August 18, 2014
NRC:14:052

AREVA Inc. Response to Request for Public Comment on the Proposed 10 CFR 50.46c Performance-Based Emergency Core Cooling Systems Cladding Acceptance Criteria (Federal Register Vol. 79, No. 56, 16106, dated March 24, 2014; Docket ID NRC-2008-0332)

AREVA Comments on 10 CFR 50.46c Proposed Rule

Fig 5. Comparison of the $\alpha(O)$ layer obtained after 3270s at 1000°C in SS-FH or DS-IH conditions; (a) SEM images; (b) % $\alpha(O)$ layer deduced from SEM images analysis; (c) projected DS-FH $\alpha(O)$ layer distribution; (d) comparison between measured DS-IH and projected DS-FH

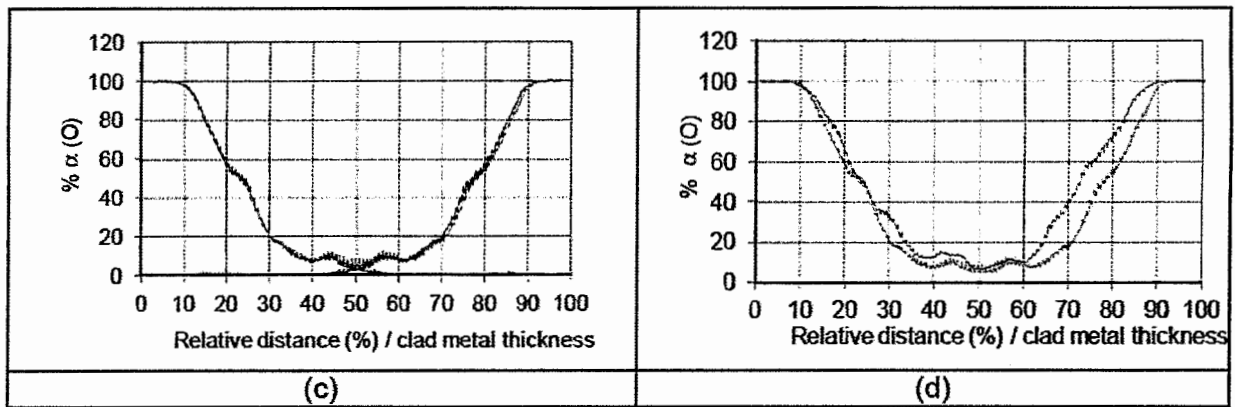
Basis for concern: As long as adequate temperature measurement and control (e.g., ramp rates) can be attained and postquench ductility is not affected by the method, the method of heating need not be specified. Previous challenges or preconceptions about the heating methods should not carry forward as prescriptions in regulatory guidance. Regardless of the heating methods, all must show thermal benchmarks.

Proposal: Recommendations for specific heating methods should be removed. Section 5.2 through 5.5 can be replaced with a single section focusing on adequate temperature control or the ability of a certain heating method to demonstrate results similar to those that are generally accepted.

Basis of proposal: Broad guidance on heating methods will encourage the development of better techniques. Furthermore, the paper, V. Vandenberghe *et al.* "Sensitivity to Chemical Composition Variations and Heating/Oxidation Mode of the Breakaway Oxidation in M5 Cladding Steam Oxidized at 1000°C (LOCA conditions)," presented at LWRFPMP, Manchester, UK, 2012 showed that the oxygen profiles were nearly identical between CINOG (induction heating) and DEZIROX (radiation heating) (see figure below). Since, for a given material and pre-hydrogen content, post-quench behavior is directly related to the prior- β thickness and oxygen content, induction heating will not impact PQD behavior.
